REQUEST FOR A SEALED SOURCE OR
DEVICE EVALUATION

Subject: Request to Amend NR-1235-S-102-S.

International Isotopes Inc. requests to amend Registry of Sealed Sources and Devices Safety Evaluation of Sealed Source Number NR-1235-S-102-S as follows:

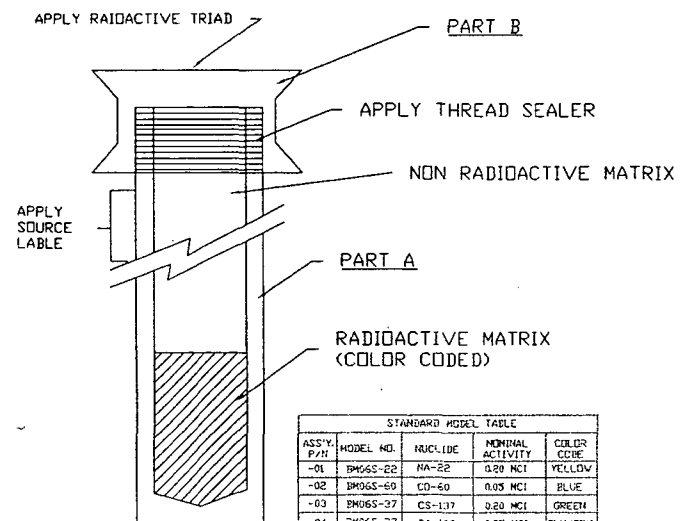
- Increase maximum activity for BM06E-68 and BM06S-68 from 0.50 mCi to 1.2 mCi.
- Change the color code for models BM06E-68 and BM06S-68 from white to purple.

A revised drawing is enclosed to replace the drawing that is currently found in Attachment 2 of NR-1235-S-102-S.
